**RE: APPROVAL WITH MODIFICATIONS
OW-61 THROUGH OW-65 WELL INSTALLATION REPORT
WESTERN REFINING SOUTHWEST INC., GALLUP REFINERY
EPA ID # NMD000333211
HWB-WRG-19-020**

RE: Response to Approval with Modifications
Investigation Work Plan Solid Waste Management Unit 1
Marathon Petroleum Company LP, Gallup Refinery
(dba Western Refining Southwest, Inc.)
EPA ID# NMD000333211

**RESPONSE TO APPROVAL WITH MODIFICATIONS SWMU-1 SOIL
SAMPLING INVESTIGATION WORK PLAN**

FIGURE 3a

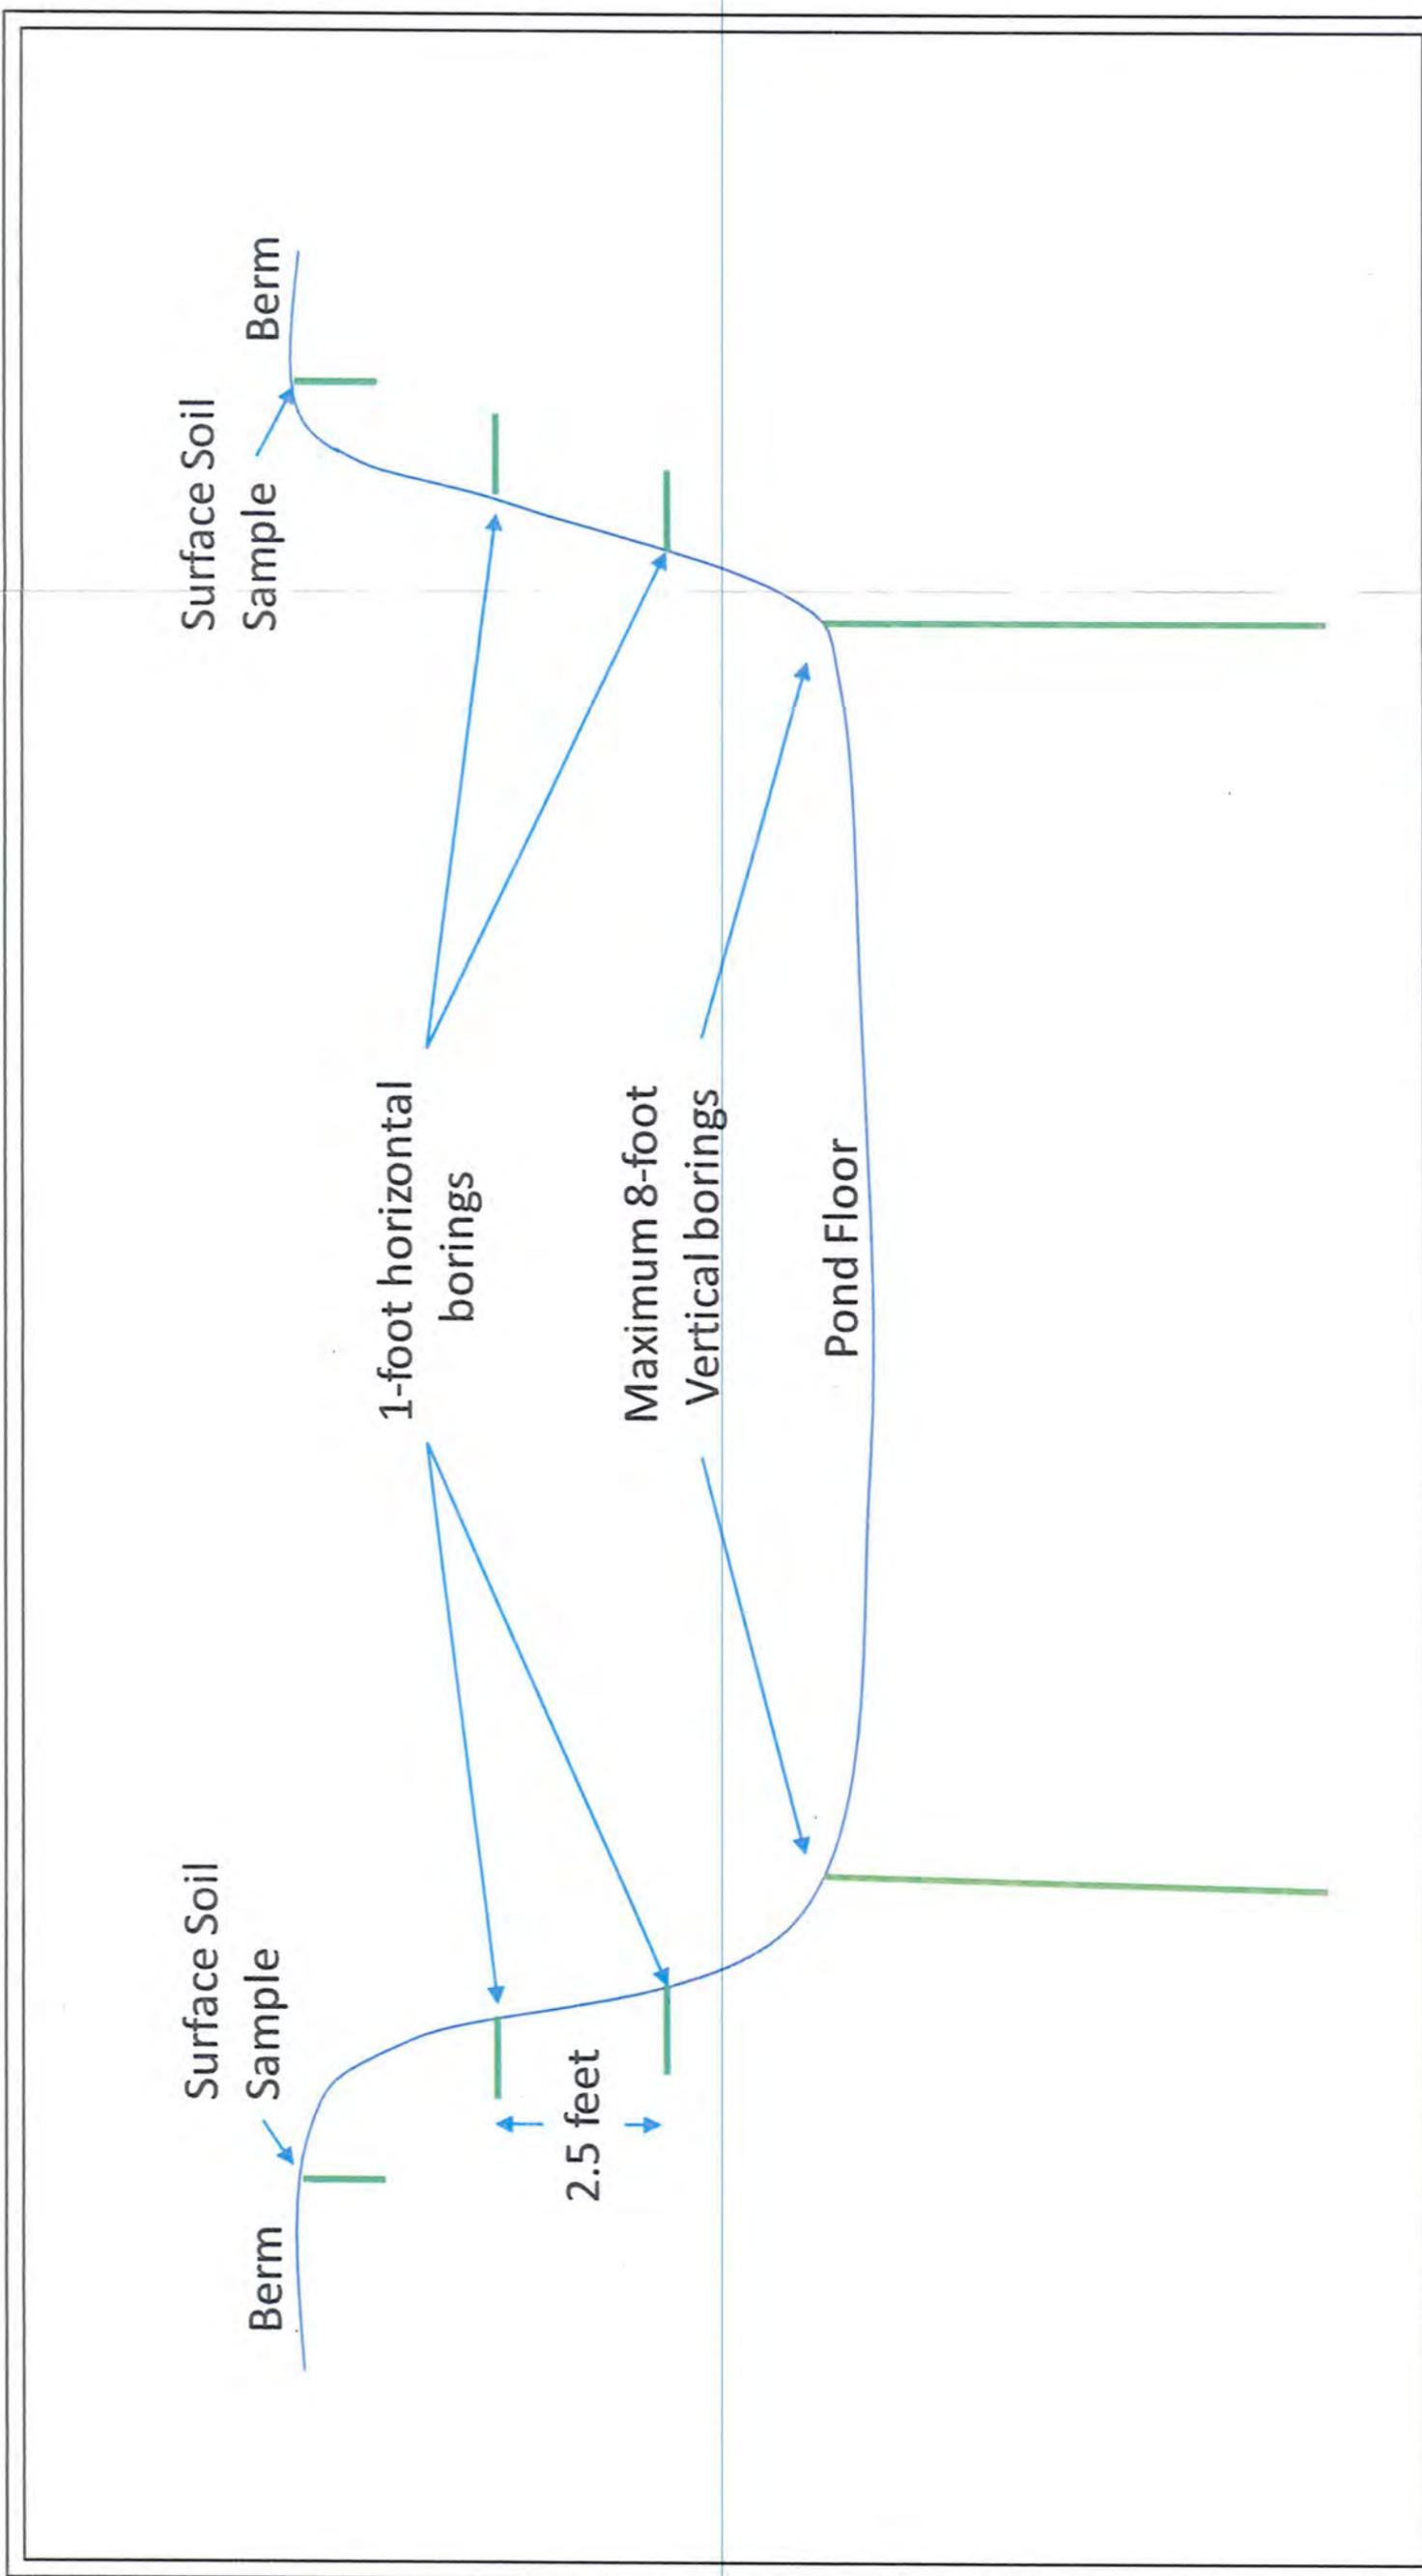
Under the heading "Investigation Methods", the Permittee states, "[s]oil samples will be collected by hand-augering within SWMU 1 and along the perimeter sidewalls (Figure 3). Discrete sediment samples will be collected at 2.5-ft intervals from the surface until visual and/or instrumental contamination is no longer evident, or until a maximum depth of approximately 8 feet is reached." The Permittee does not specify if the berm sidewall samples will be collected using a hand auger or with a different tool and does not specify to what depth/horizontal position the berm sidewall samples will be collected. Provide this information in a response letter.

SWMU 1 sidewall soil samples along the berm will be collected using a hand auger. The first sample will be collected from the top surface of the berm and advanced 1-foot vertically into the berm. The next sample will be collected approximately 2.5-foot below the top of the berm (Figure 3a) and advanced 1 foot horizontally into the berm side wall. Additional samples will be collected approximately at 2.5-foot intervals until the toe of the berm is reached. Samples at the toe of the

berm will be collected vertically from the surface, at 2.5-foot intervals to an 8-foot maximum depth or until visual staining and/or no instrumental response is detected (Figure 3a). A sample will also be collected from any saturated intervals.
